# Coulderton and Nethertown, Cumbria

Natural England's Variation Report to the Secretary of State

Coastal Access Variation Report VR2  
1st August 2018

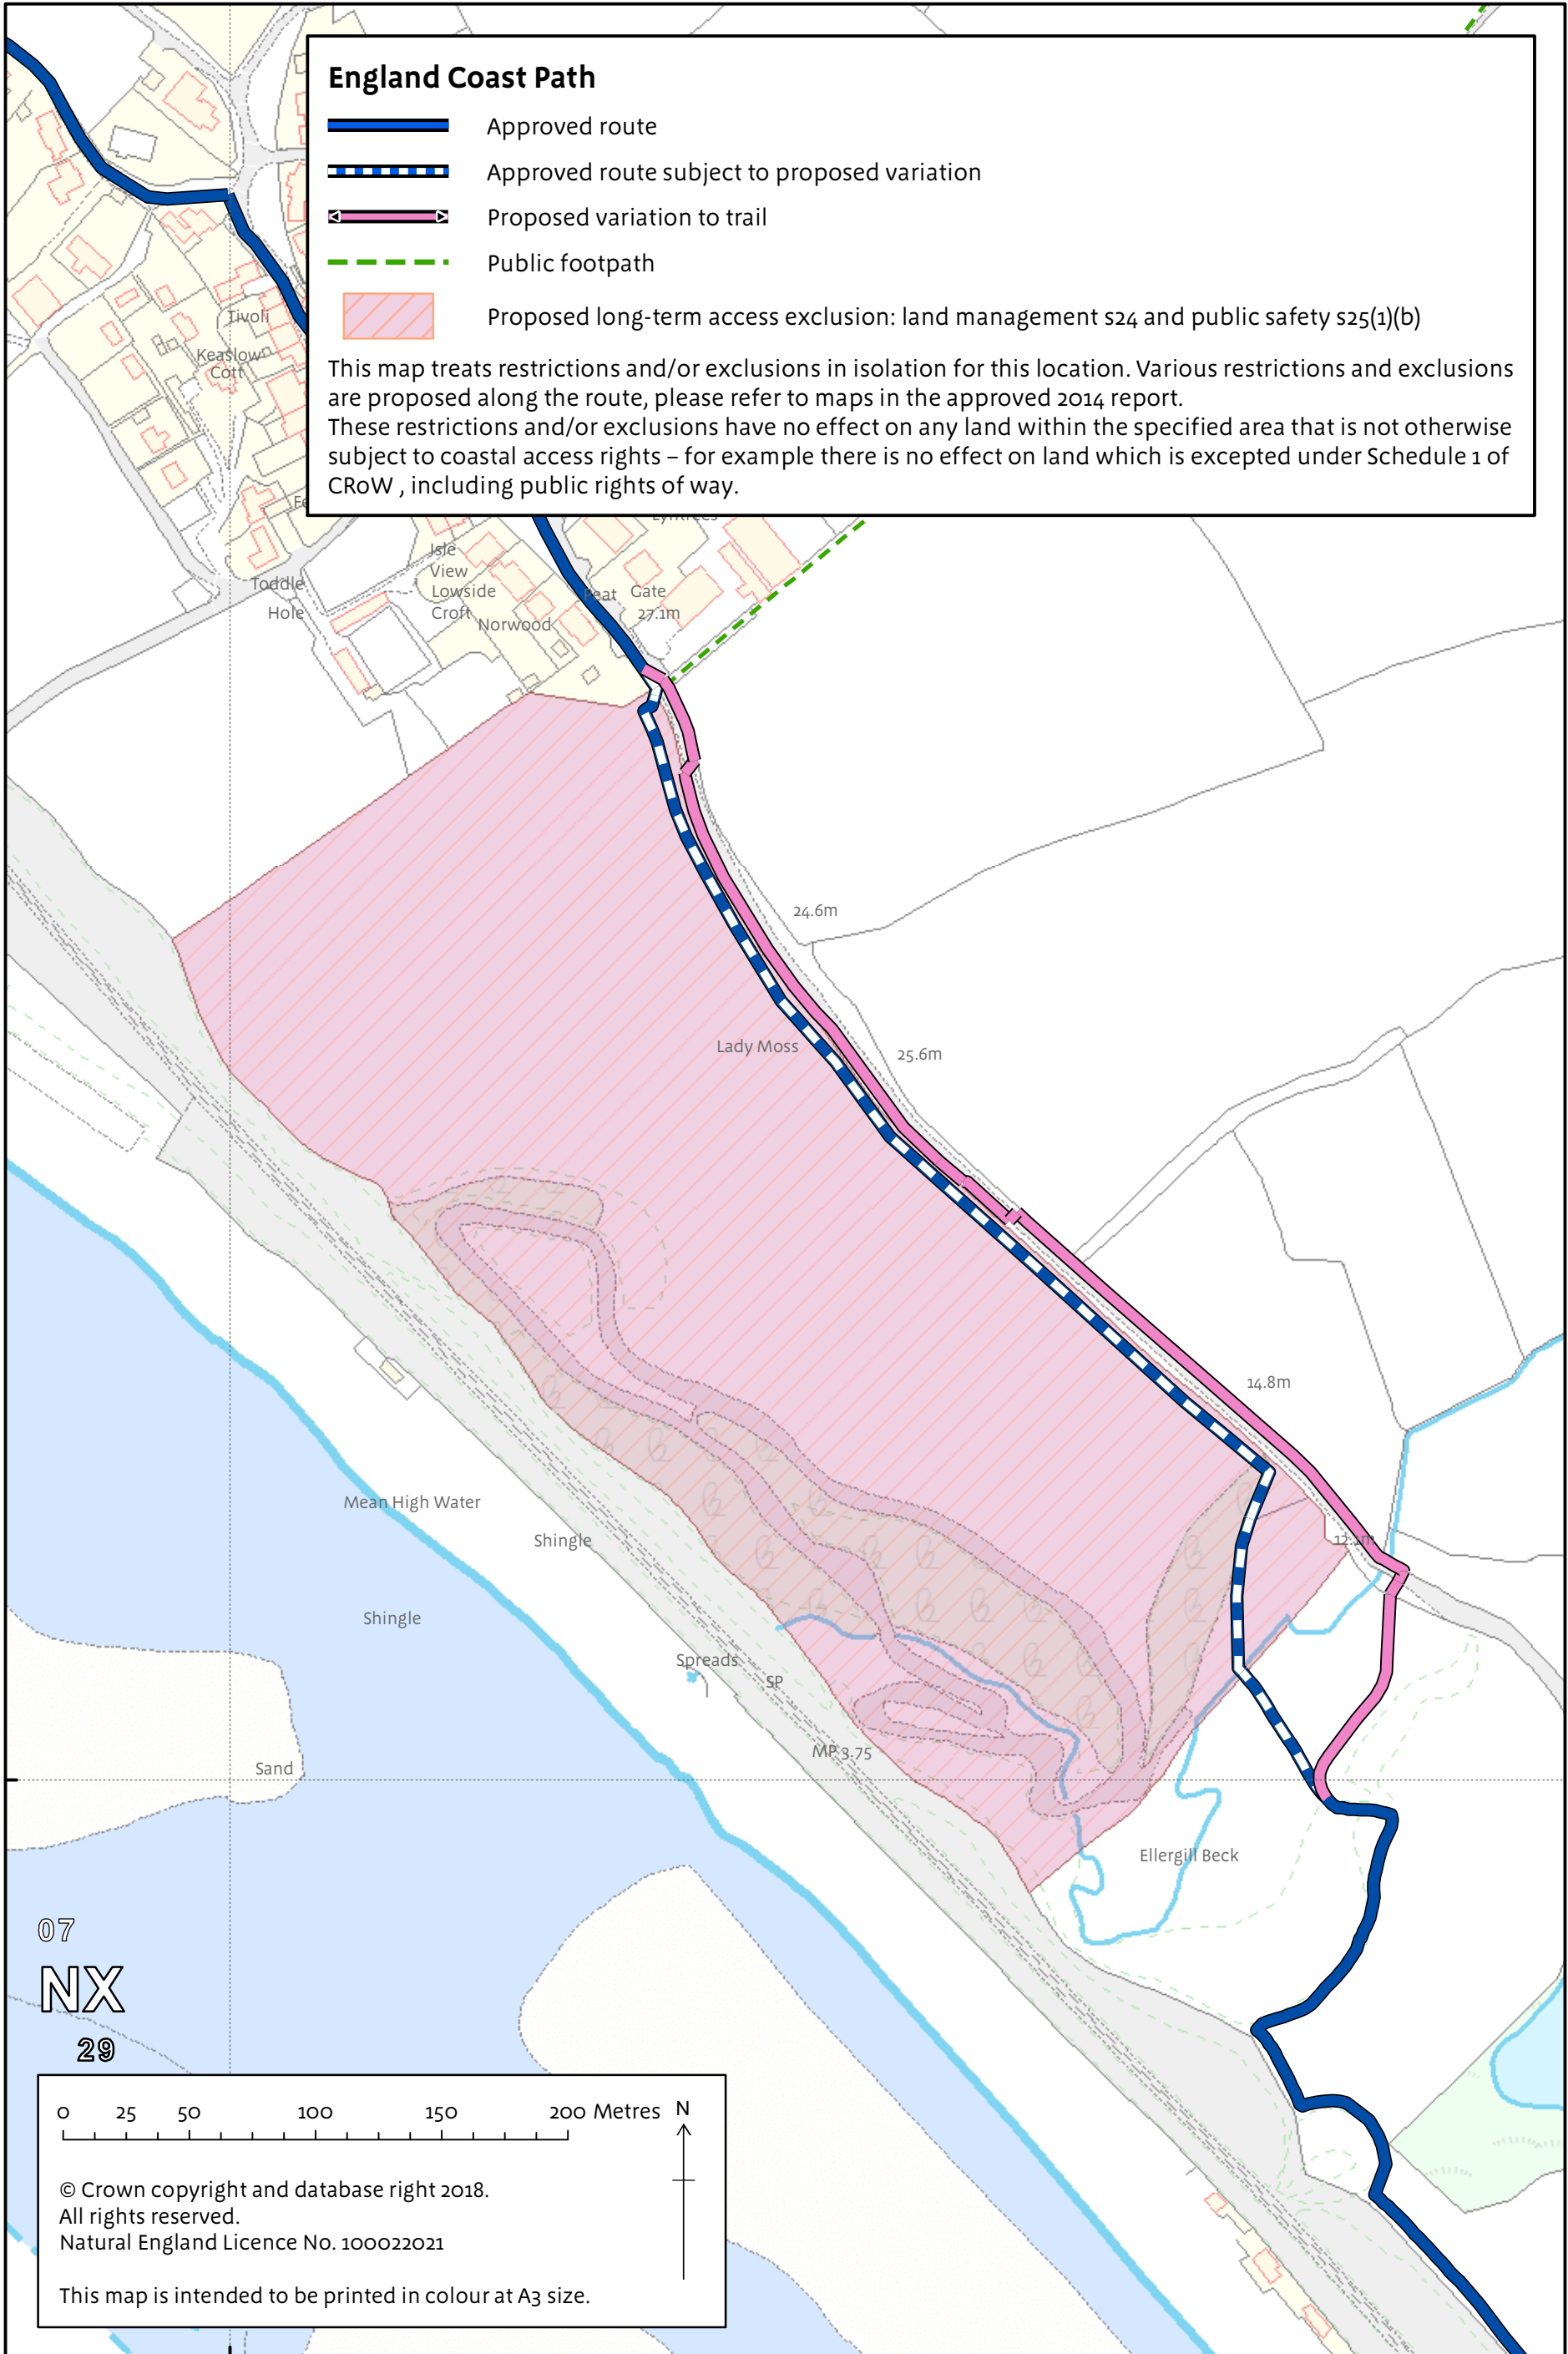
A long-term access exclusion affecting the coastal margin was approved previously. This exclusion will still be required, despite the proposed variation, although the boundaries of the excluded area will be modified slightly as a consequence of the proposed route variation (map VR2c). Furthermore, access rights to the spreading room would be subject to the national restrictions on coastal access rights.

The previously approved exclusion covering much of the land at Lady Moss, south of Nethertown, would be extended slightly so as to cover the entire land parcel (map VR2c). All other aspects of the exclusion remain unchanged from that which was previously approved.
